**Re: Response to Comments – Comment Letter Pre & Post Closure Groundwater Sampling Plan RTC (July 6, 2022)
Hess Corporation Former Port Reading Complex (HC-PR)
750 Cliff Road
Woodbridge, Middlesex County, New Jersey
NJDEP PI# 006148
ISRA Case No. E20130449
EPA ID No. NJD045445483**

Earth Systems, Inc. (Earth Systems) has prepared this letter on behalf of Hess Corporation (Hess) in response to the July 6, 2022 comment letter regarding the Pre & Post Closure Groundwater Sampling Plan Response to Comments (RTC) submitted by Hess and Earth Systems on April 22, 2022.

NJDEP Comments & Earth Systems/Hess Responses

OIL SUMP
NO SCALE

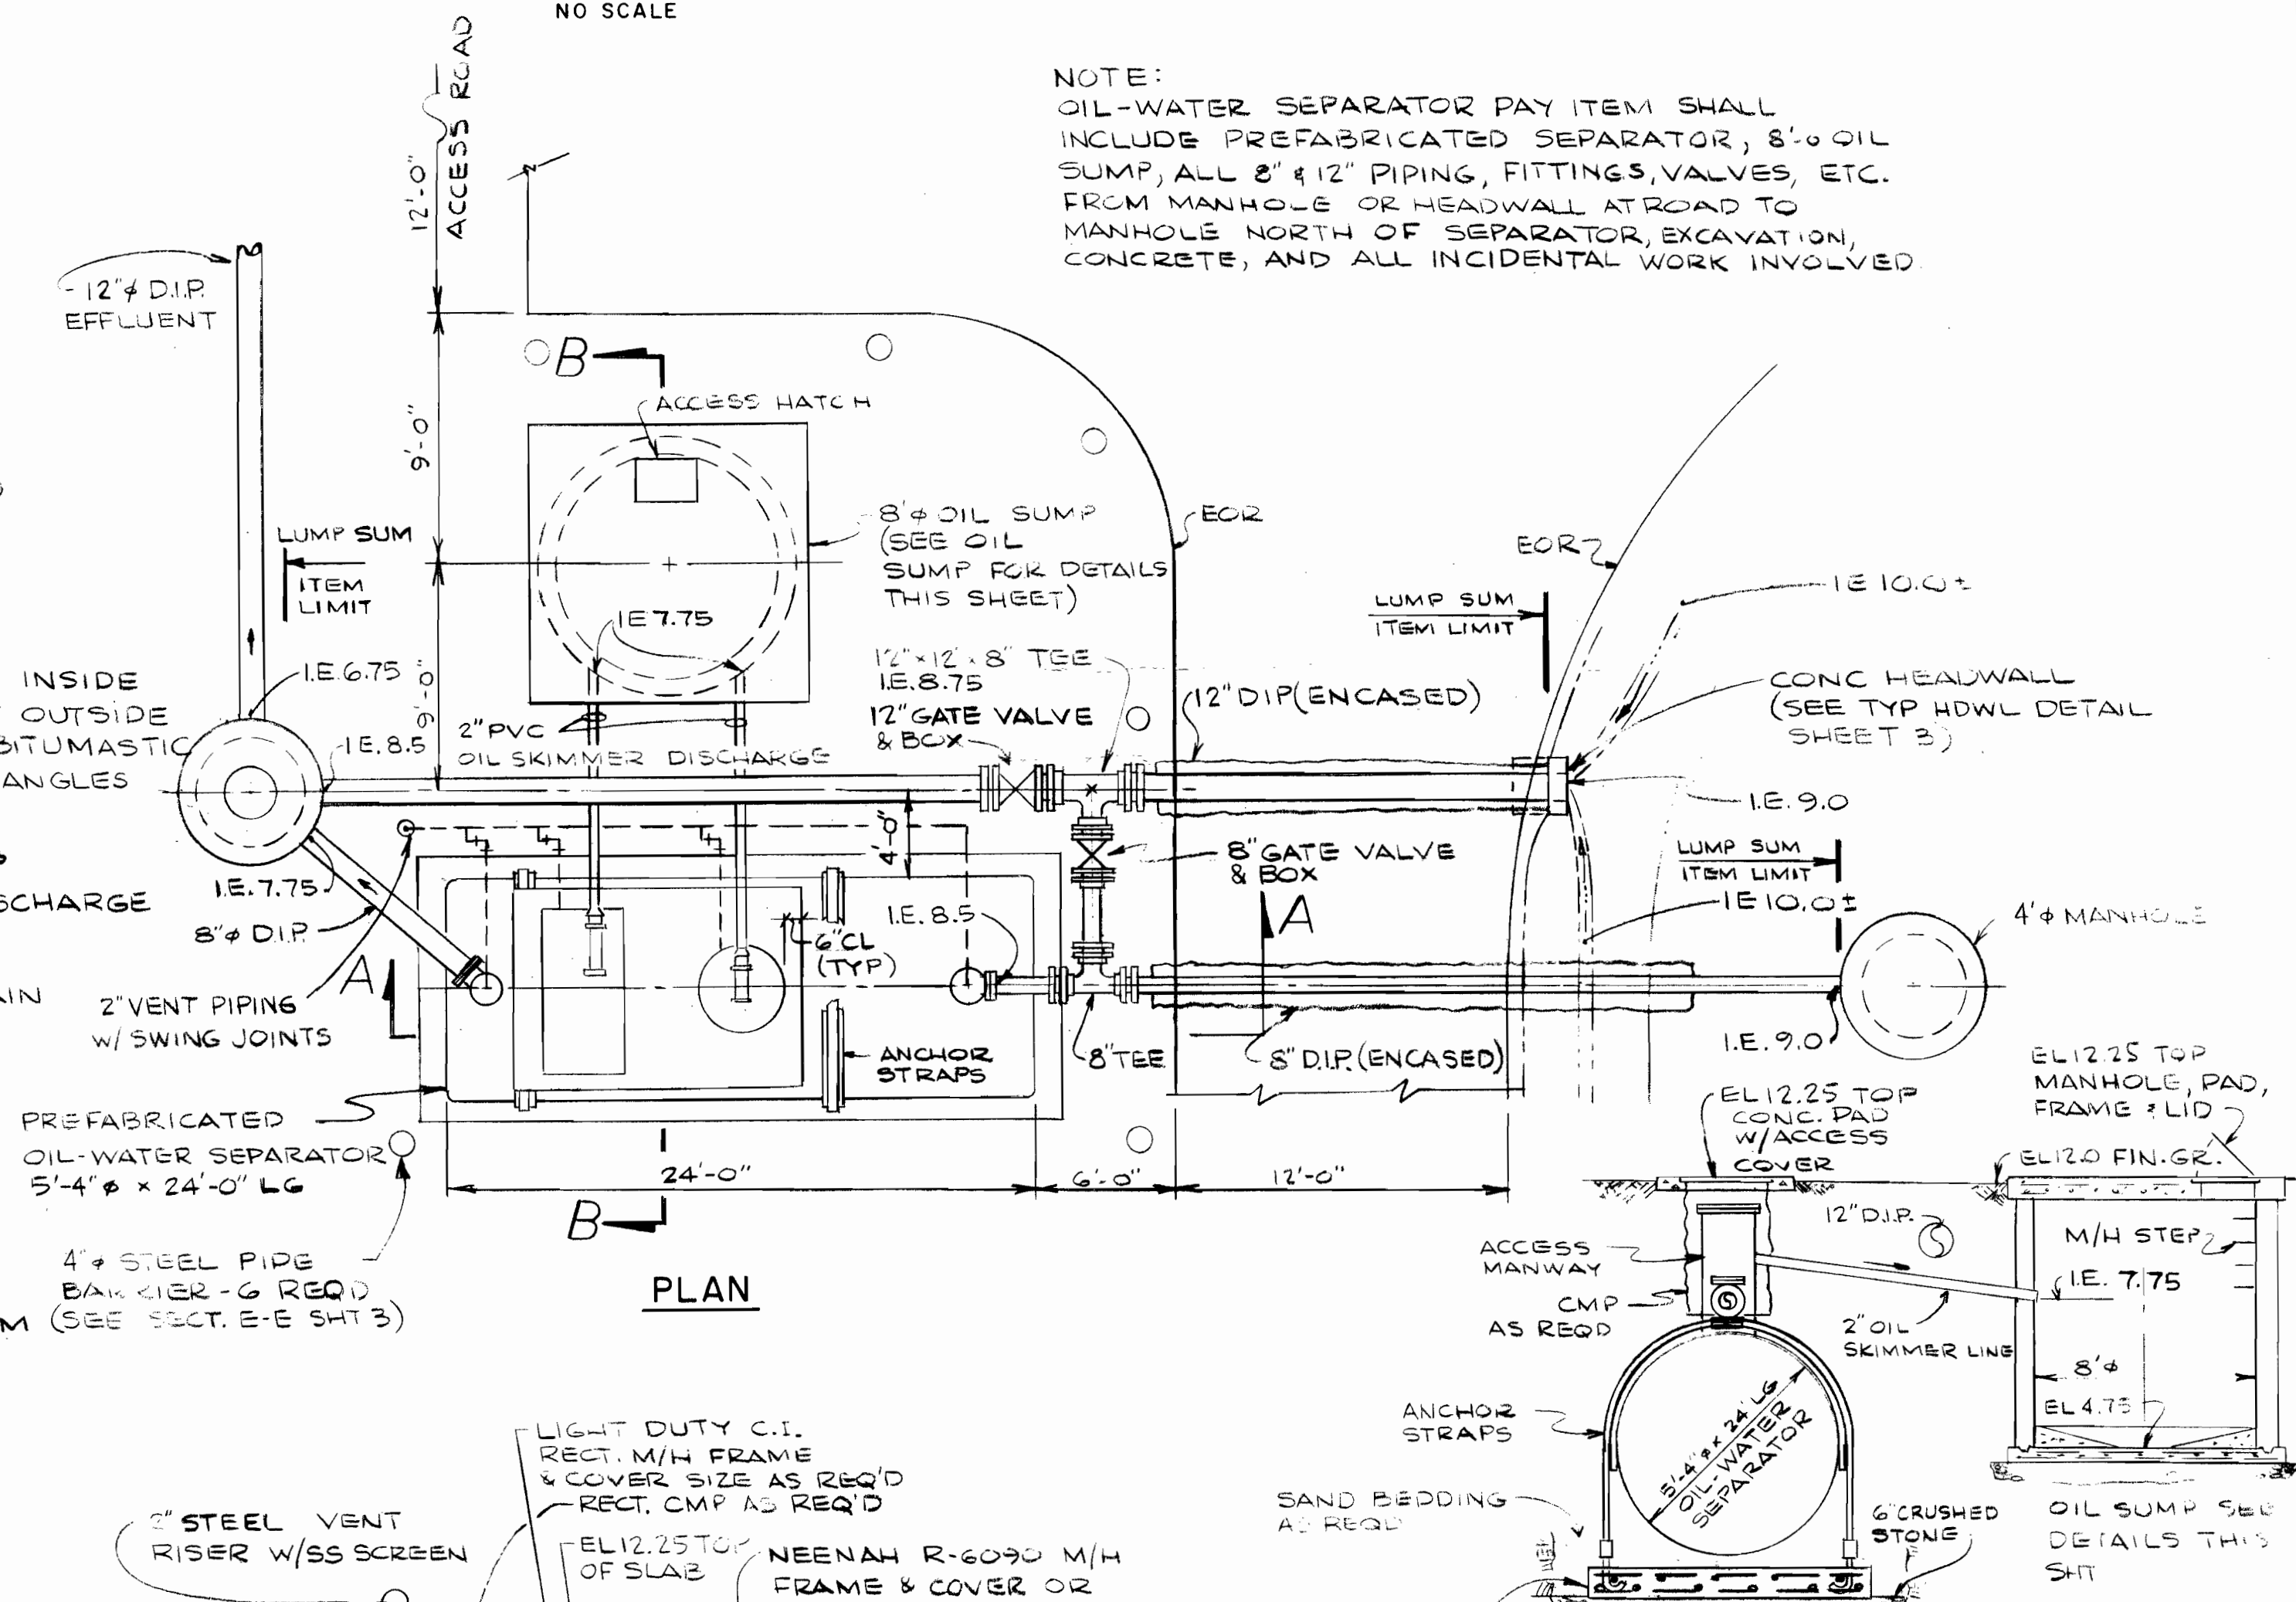
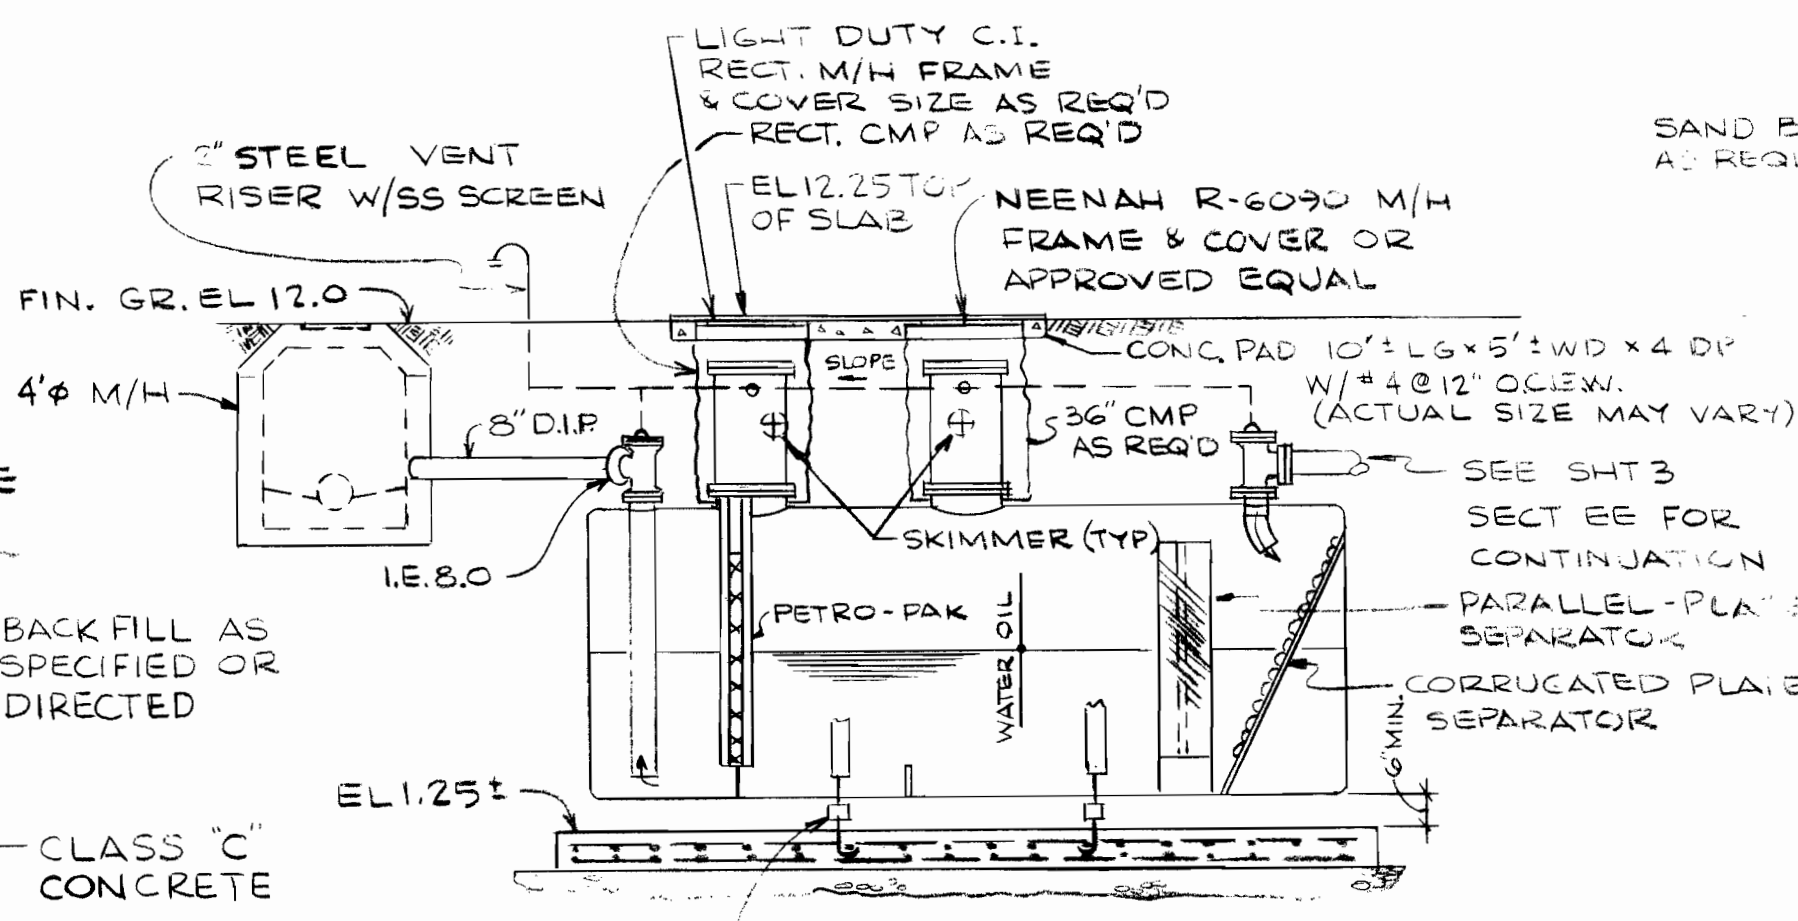
- Clarify: 1) which access point will be used for sampling based on below drawing and actual site conditions, and 2) whether both the float/vent pipe and withdrawal pipes are screened pipe sections (the withdrawal pipe appears to be slotted within the sump but the saved drawing section for the vent pipe with the float ball isn't clear).
 - All pipe sections are steel casing, and no screened piping is present. The steel casing that houses the liquid level sensor will be the access point to the leachate sump for future leachate sampling.
- Assess sediment accumulation in the sump.
 - A visual inspection of the sump will be conducted prior to sampling to determine if there is sediment accumulation.
- As part of sampling plan:
